UNITED STATES
NUCLEAR REGULATORY COMMISSION
WASHINGTON, D.C. 20555-0001

SUBJECT: MONTICELLO NUCLEAR GENERATING PLANT - STAFF ASSESSMENT OF INFORMATION PROVIDED PURSUANT TO TITLE 10 OF THE *CODE OF FEDERAL REGULATIONS* PART 50, SECTION 50.54(f), SEISMIC HAZARD REEVALUATIONS FOR RECOMMENDATION 2.1 OF THE NEAR-TERM TASK FORCE REVIEW OF INSIGHTS FROM THE FUKUSHIMA DAI-ICHI ACCIDENT (TAC NO. MF3958)

STAFF ASSESSMENT BY THE OFFICE OF NUCLEAR REACTOR REGULATION
RELATED TO SEISMIC HAZARD AND SCREENING REPORT
MONTICELLO NUCLEAR GENERATING PLANT
DOCKET NO. 50-263

Figure 3.3-1 Plot of Staff's and Licensee's Base Case Shear-Wave Velocity Profiles for the Monticello Site

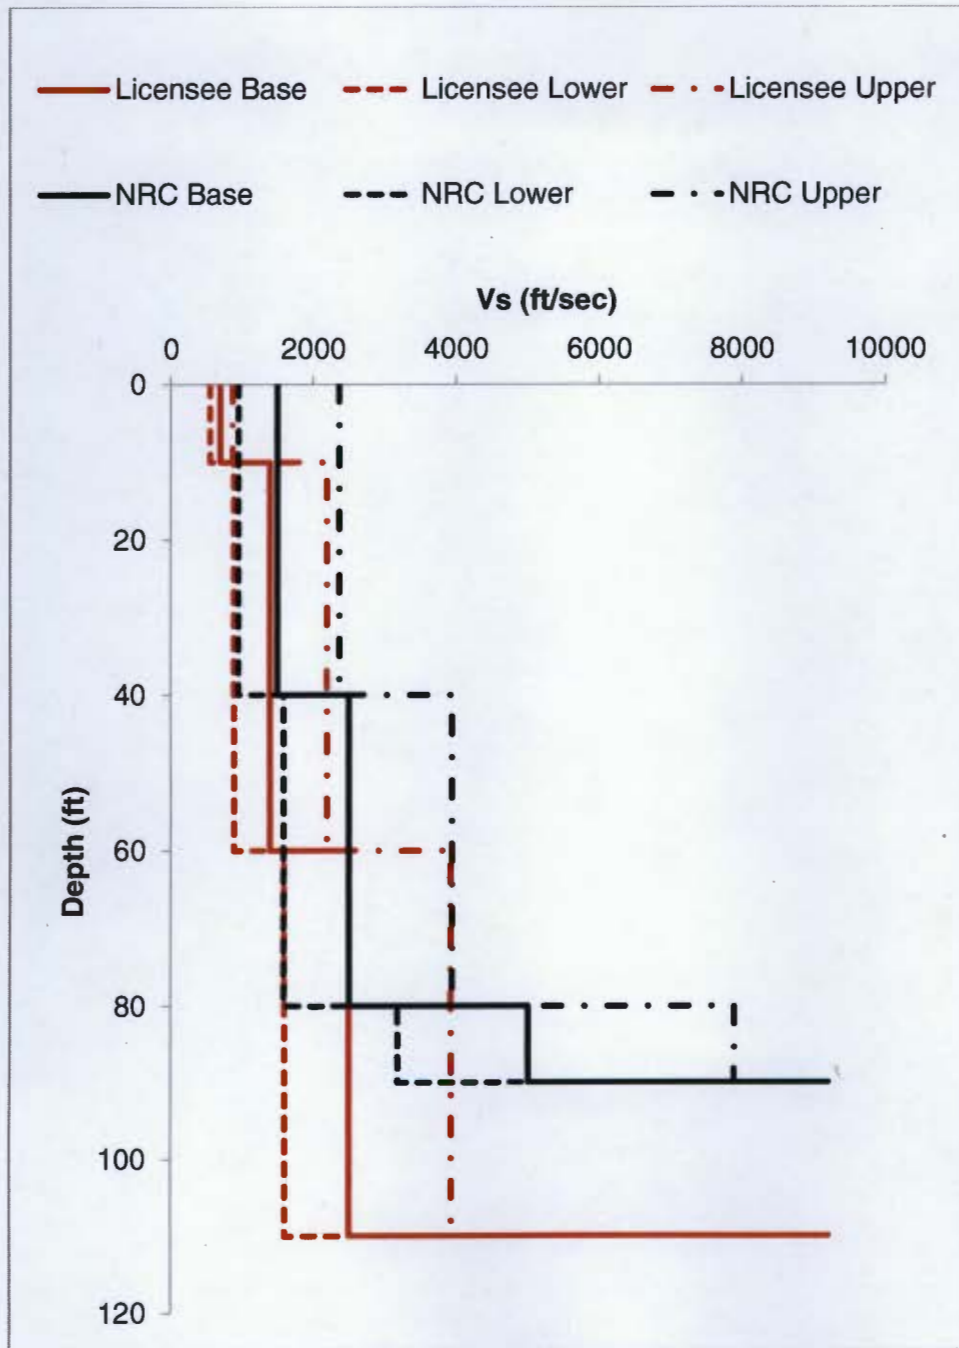
The staff performed independent calculations to confirm that the licensee's amplification factors and control point hazard curves adequately characterize the site response, including the uncertainty associated with the subsurface material properties, for the Monticello site. The staff independently developed three base case shear-wave velocity profiles from information provided in the USAR. The staff's base case shear-wave velocity profiles are shown along with the licensee's base case profiles in Figure 3.3-1 of this assessment. The staff's shear wave velocity profiles agree with those submitted by the licensee with only a minor difference in the estimated depth to bedrock.

Figure 3.3- 1 Plot Comparing the Staff's and the Licensee's Median Amplification Functions and Uncertainties for the Monticello site.

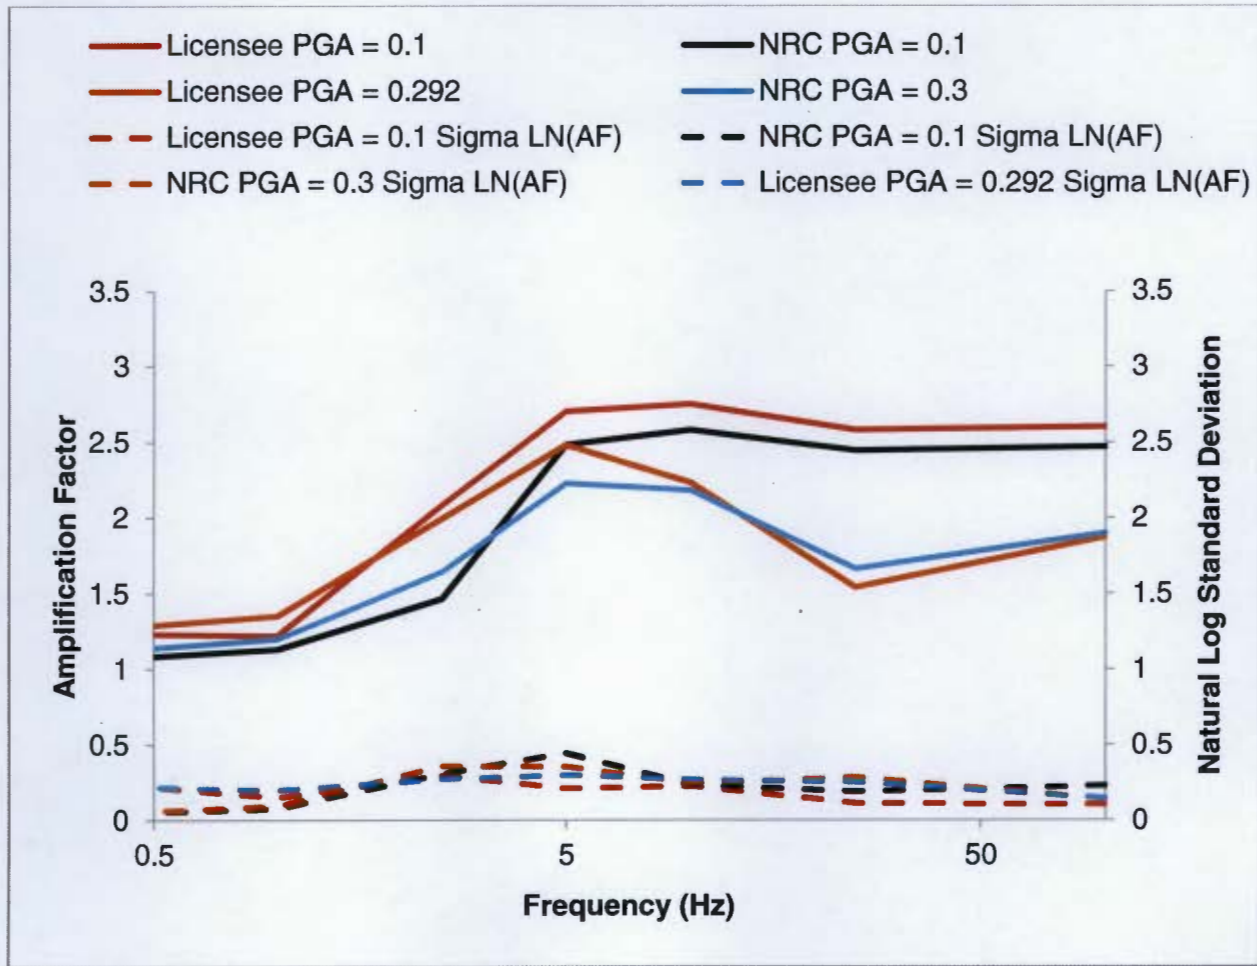
In order to calculate control point hazard curves for the Monticello site, the licensee and staff developed median amplification functions for the site for several different loading levels, representing the possible hazard at the Monticello site. The licensee's and staff's median site amplification functions and associated uncertainty for two separate loading levels are shown in Figure 3.3-2 of this assessment. It can be seen that both the staff's and licensee's site amplifications are similar in shape with only a slight differences for the higher frequencies. Figure 3.3-3 of this assessment shows the licensee's and staff's control point hazard curves resulting from the convolution of the site amplification with the PSHA rock hazard curves. As shown in Figure 3.3-3, the licensee's and staff's results are very similar.

Figure 3.4-1 Comparison of the Staff's GMRS with Licensee's GMRS and the SSE for the Monticello site

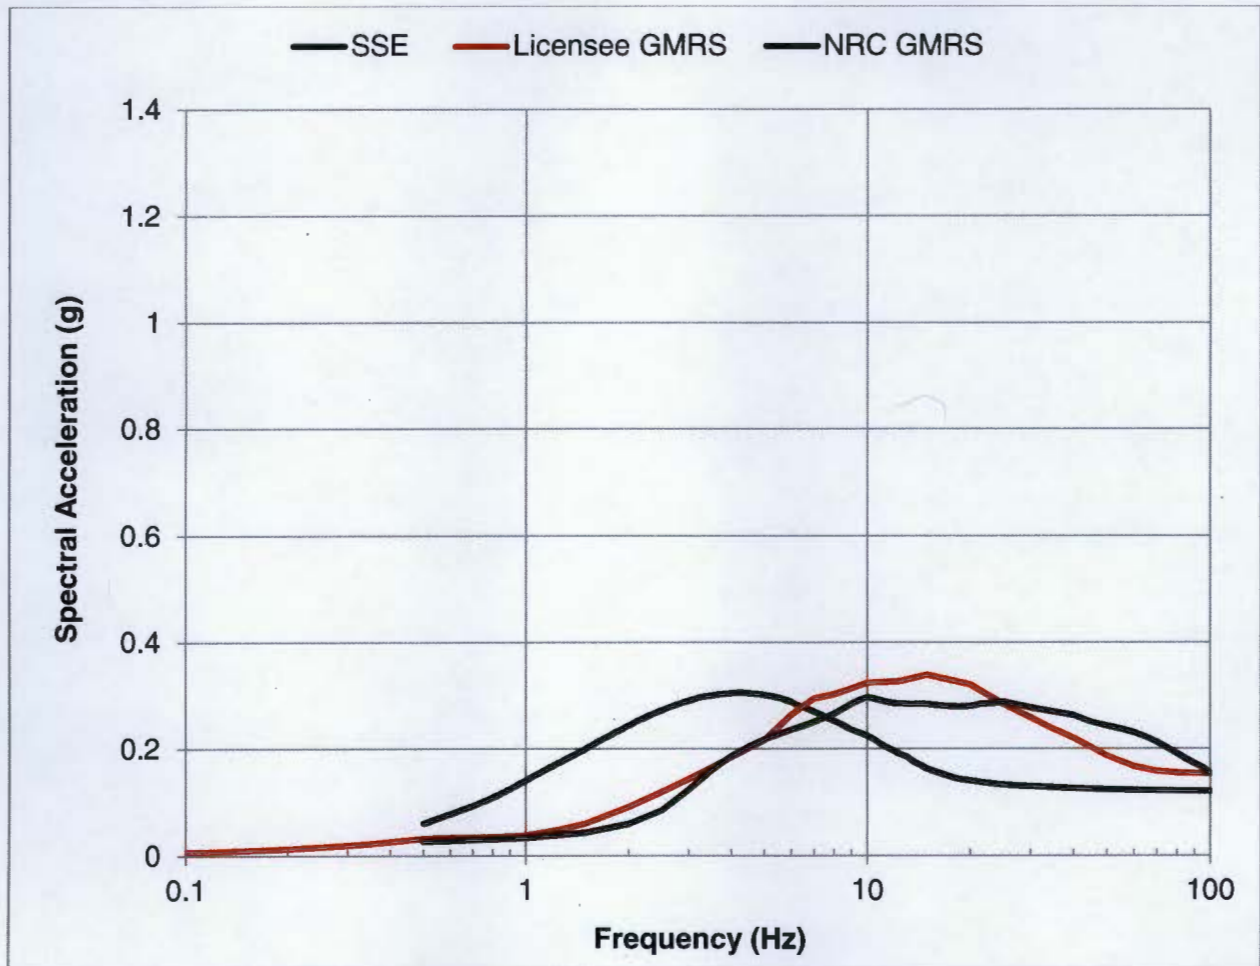
The NRC staff independently calculated the 10^{-4} and 10^{-5} UHRs using the results of its confirmatory PSHA and site response analysis, as described in Sections 3.2 and 3.3 of this staff assessment, respectively. Figure 3.4-1 of this assessment shows a comparison of the GMRS determined by the licensee to that determined by the staff. As shown in Figure 3.4-1 below, the licensee's GMRS shape is generally similar to that calculated by the staff. At frequencies where the amplitude of the GMRS determined by the licensee is different from that determined by the staff, the licensee's generally exceeds that of the staff. These differences in GMRS are the result of differences in the site response analyses performed by the licensee and staff as discussed in Section 3.3 above. The NRC staff concludes that these differences are acceptable for this application because the licensee followed the guidance provided in the SPID with respect to both the PSHA and site response analysis for the Monticello site.

In reaching this determination, the NRC staff confirmed the licensee's conclusion that the licensee's GMRS exceeds the SSE for the Monticello site in the frequency range of 1 to 10 Hz, and also in the frequency range above 10 Hz. As such, a seismic risk evaluation, SFP evaluation and high-frequency confirmation are merited. The licensee indicated that the high frequency confirmation would be performed as part of its seismic risk evaluation. The NRC review and acceptance of the NSPM plant seismic risk evaluation with the high frequency confirmation, and also an interim ESEP evaluation and SFP evaluation (i.e., Items (4), (6), (8), and (9)) for Monticello will complete Seismic Hazard Evaluation identified in Enclosure 1 of the 50.54(f).
